Renewable Natural Gas Request for Proposals

Responses to Questions Received

Monday, March 10, 2025

A schematic of the NEWPCP digesters heating and recirculation is provided below; the process flow is similar for the SWWPCP.

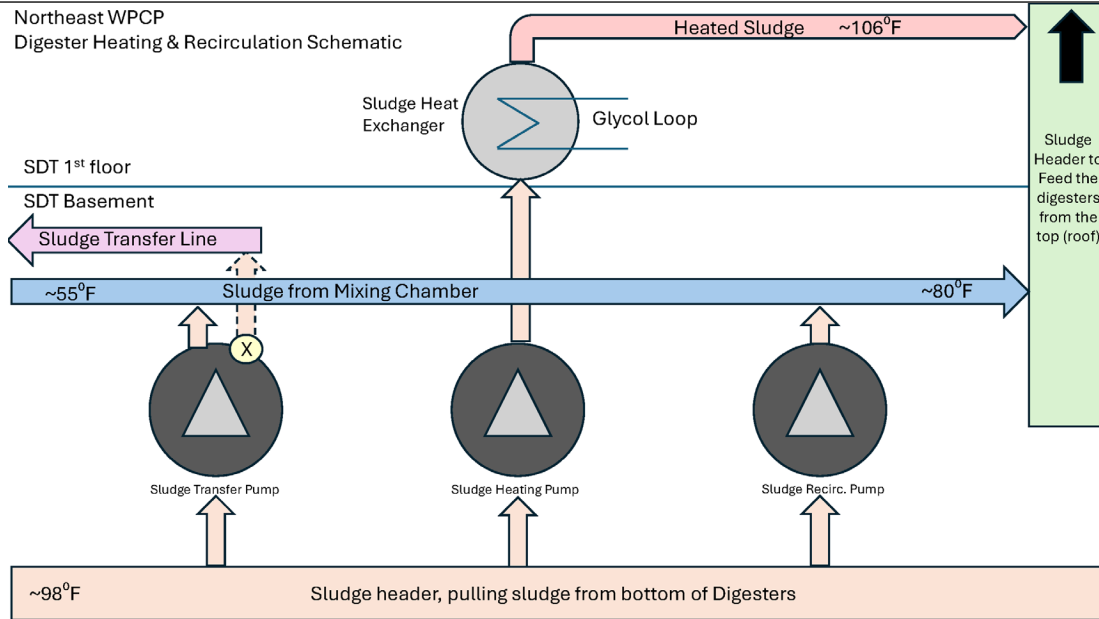
19. How is PWD currently mixing the digesters?

A: Mixing of the digesters is achieved through sludge recirculating and sludge heating pumps.

The sludge recirculating pump provides continuous sludge circulation to keep digester contents well mixed and to prevent heavy solids accumulating in the bottom of the tank. The sludge recirculating pump draws suction from the bottom of the conical portion of the digester and pumps sludge back up to the top of the tank.

The sludge heating pump provides a continuous sludge flow to the sludge heat exchanger for each digester, as well as another means of circulating sludge to ensure the contents of the digester are well mixed. The sludge heating pump draws suction from the bottom of the conical portion of the digester and pumps sludge through the sludge heat exchanger and back into the top of the tank.
